Access Compliance Report

Public Rights-of-Way (Curb Ramps)

Intersection ID: 30454	Main Street: SHALOM_PARK_DR	Cross Street: PROVIDENCE_RD	Location: SE
ADA ID: 1FAD5397CE15	Ramp Type: BlendTrans2	Initial Pass/Fail: Fail	Overall Compliance: No
		Severity Score: 12.5

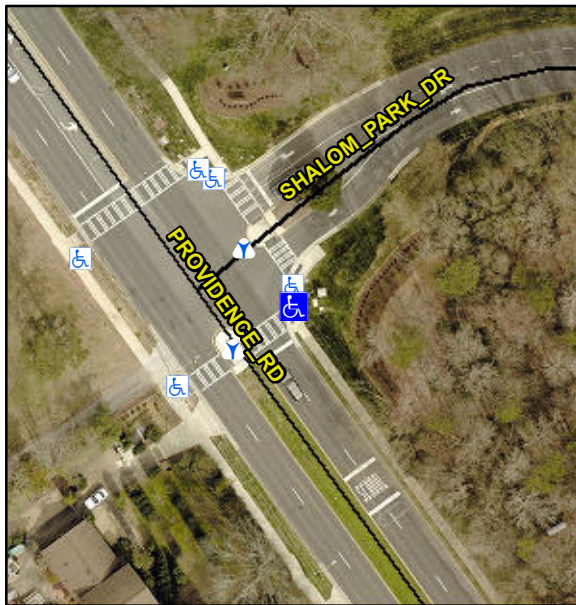
R304.5.3

Compliance	Description	Data	Compliance	Description	Data
N/A	Ramp Length (in)	70.0	Yes	BlendTrans Slope (%)	0.5
Yes	Ramp Width (in)	70.0	No	BlendTrans XSlope (%)	5.4
N/A	Flare Type LT	N/A	N/A	Flare Type RT	N/A
N/A	Flare Slope LT (%)	N/A	N/A	Flare Slope RT (%)	N/A
N/A	Flare Traversable LT?	N/A	N/A	Flare Traversable RT?	N/A
N/A	Landing Length (in)	N/A	N/A	DWS Provided?	N/A
N/A	Landing Width (in)	N/A	N/A	DWS Contrast?	N/A
N/A	Landing Slope (%)	N/A	N/A	DWS Length (in)	N/A
N/A	Landing X Slope (%)	N/A	N/A	DWS Full Width?	N/A
N/A	Landing Curb? (Y/N)	N/A	N/A	DWS Offset (in)	N/A
N/A	Shared Landing?	N/A			
N/A	Gutter Ponding?	N/A	N/A	Gutter Slope (%)	N/A
N/A	Gutter Lip Ht (in)	N/A	N/A	Gutter X Slope (%)	N/A
N/A	Painted X Walk1?	Yes	N/A	Painted X Walk2?	N/A
	X Walk 1 Direction	To SW		X Walk 2 Direction	N/A
	X Walk 1 Width (in)	115.0		X Walk 2 Width (in)	N/A
	X Walk 1 Slope (%)	4.1		X Walk 2 Slope (%)	N/A
	X Walk 1 X Slope (%)	4.8		X Walk 2 X Slope (%)	N/A

Remove & Replace Curb Ramp With Two New Directional Ramps or Equivalent.
